SUBJECT: Clearance of Report

1. On 17 March 1964 there was forwarded by this office, for release to the Office of Technical Services, Department of Commerce, Contract Report No. 2-67, July 1963, by Jathan M. Newmark, entitled: "Design of Openings for Buried Shelters".

2. Errata sheets are attached for this report.

Revised Charts 6.03 and 6.04 are attached to replace the charts contained in the report. The curves in the original charts were based on elementary considerations that yield results now found to be non-conservative under some circumstances. The revised curves are obtained with the use of a somewhat more sophisticated analysis.

CHART 6.03 BARRIER REDUCTION FACTOR VERSUS 1965 THICKNESS FOR 2.5 NEV NEUTRONS

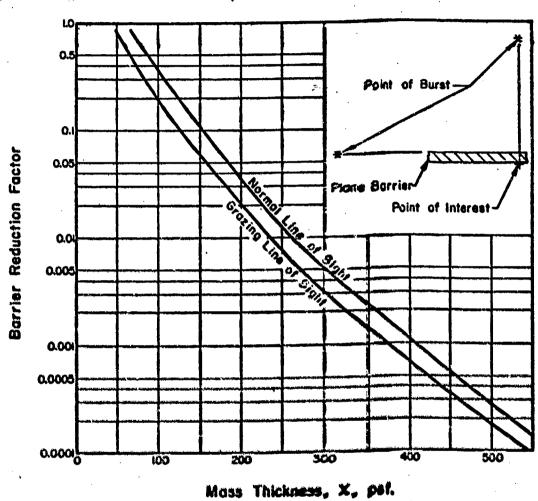
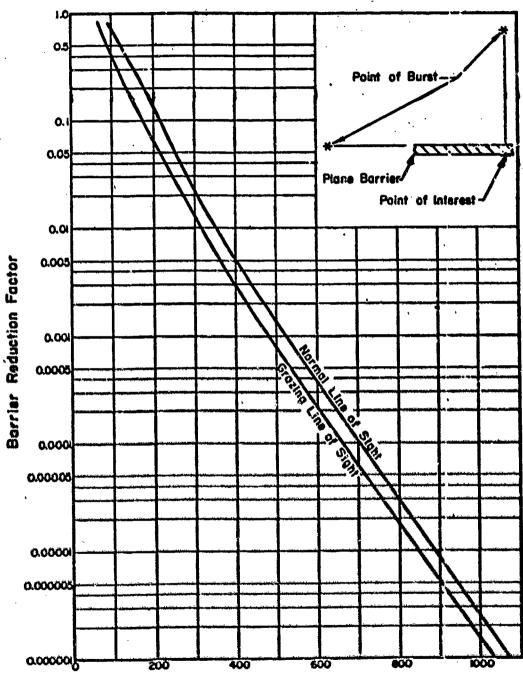
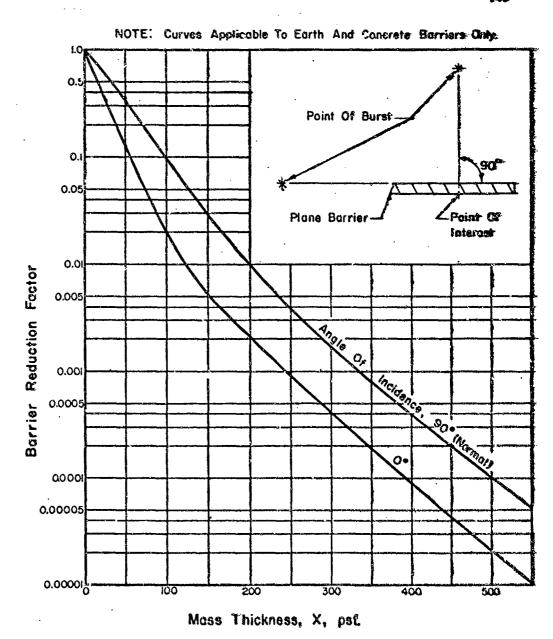
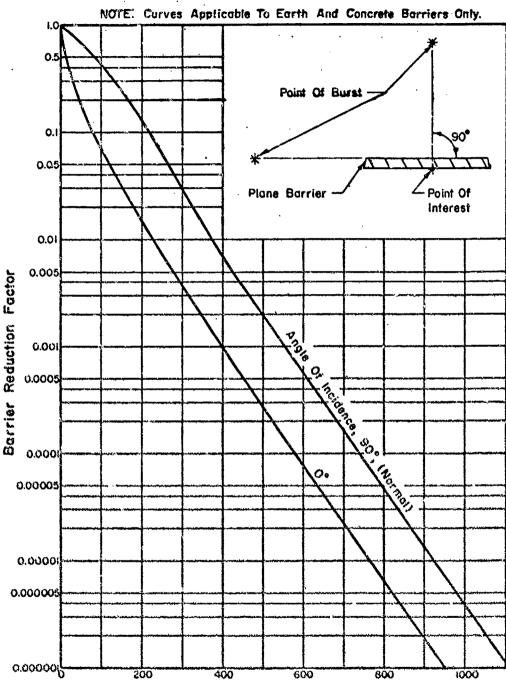
The revised curves are calculated with the use of information available in a report by Spielberg and Duneer. In particular, they are based upon dose rate curves for neutrons incident at various angles upon material designated as "R10," which is representative of ordinary concrete and generally of most earth with a mcisture content of about 10% by weight. (They are conservative if the water content is higher, but err in the non-conservative direction if the water content is lower.) The data from Spielberg and Duneer must be weighted by the proportion of neutrons which are incident on the barrier at various angles to the normal. Since the data in Spielberg and Dunear are given for angles of incidence of 0°, 20°, 45°, and 75°, some assumptions must be made as to the assignment of the percentage of incident neutrons to each of these directional groups, for the two cases of "normal" and "grazing" line of sight. The discussion in Section 5.04 gives some information relative to this assignment, but judgment must be employed also. The assumed angular distributions, applicable to both 2.5 MeV and 14 MeV neutrons, are as follows:

The reader should be advised that the illustrative example given in Chapter 9 of the basic report uses the data from the original curves in Charts 6.03 and 6.04, and are incorrect to that extent. The methods employed, however, are unchanged.
